San Francisco Roundtable Technical Working Group

September 26, 2019

Federal Aviation
Administration

This presentation is in response to the San Francisco Roundtable's (SFO RT) request for information in their August 22, 2019 letter to the FAA. For brevity, many of SFO RT's requests have been summarized.

SFO RT Request 1g

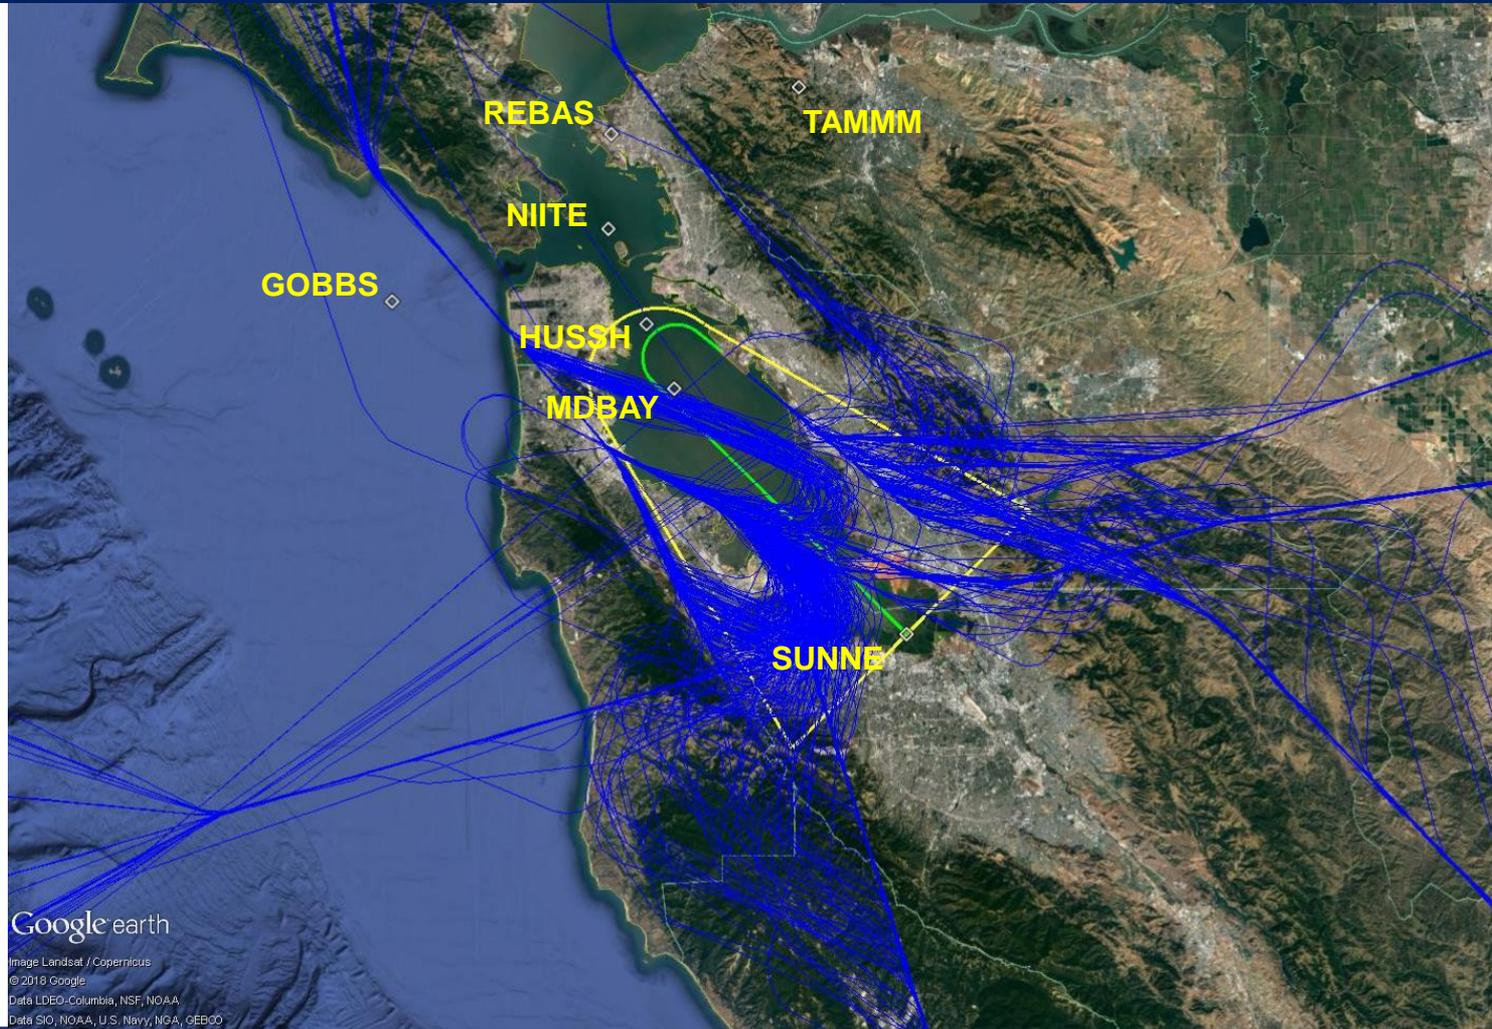
1g. Current NIITE and HUSSH noise abatement procedure with proposed conventional SUNNE departure

NOTE: The depicted SUNNE departure is an estimation only. Because SUNNE is a conventional procedure, actual flight tracks will vary.

SFO RT Request 4c

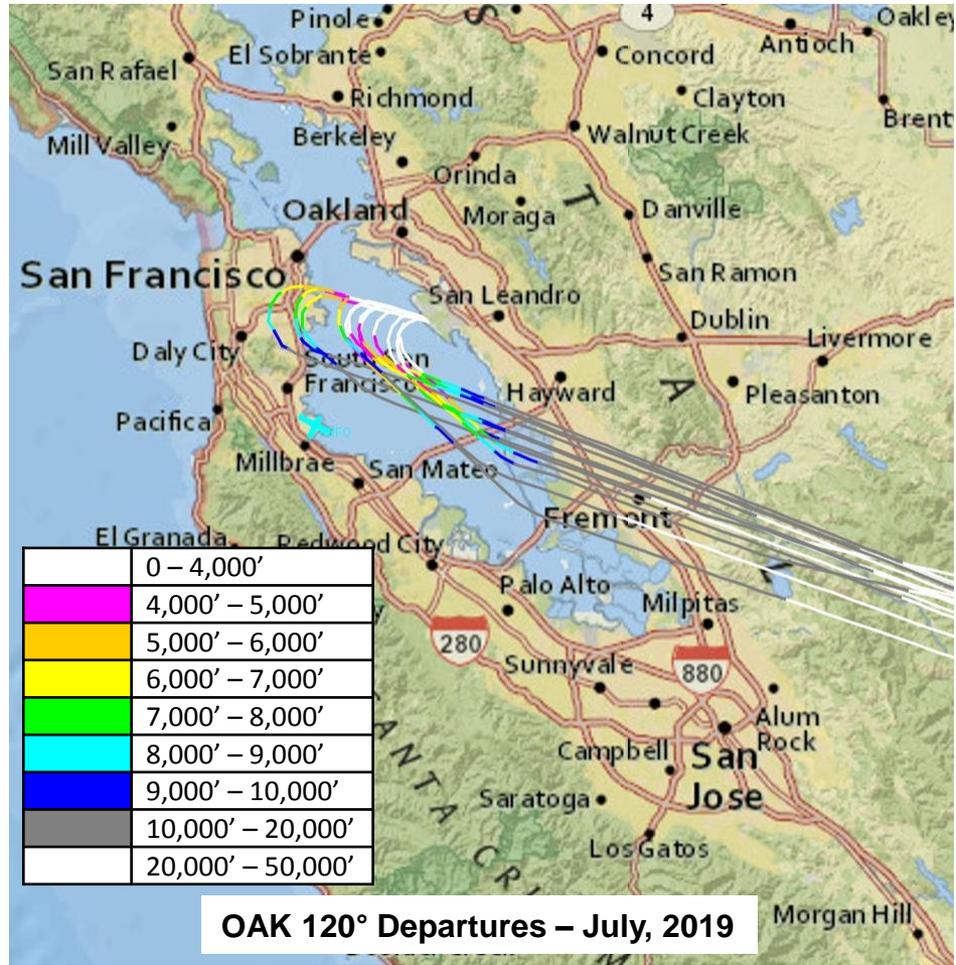
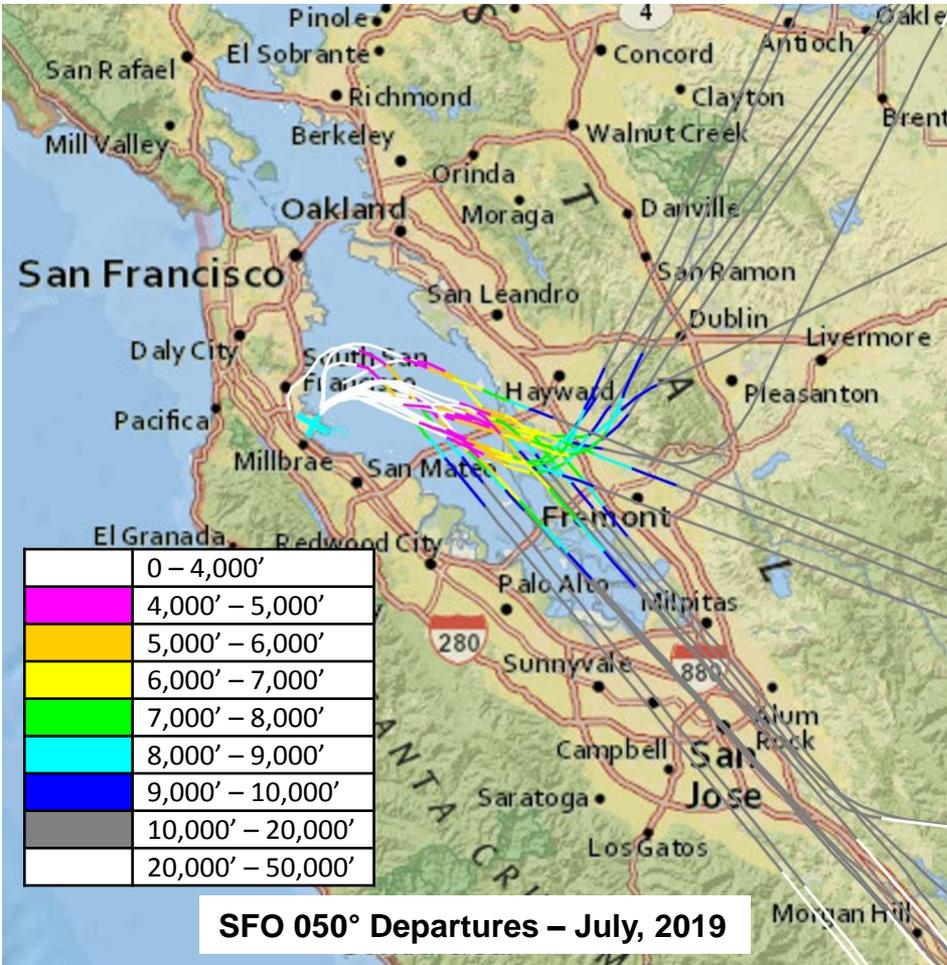
4c. Please provide Google maps showing SFO 050° and OAK 120°.

FAA Response: Please see next slide.
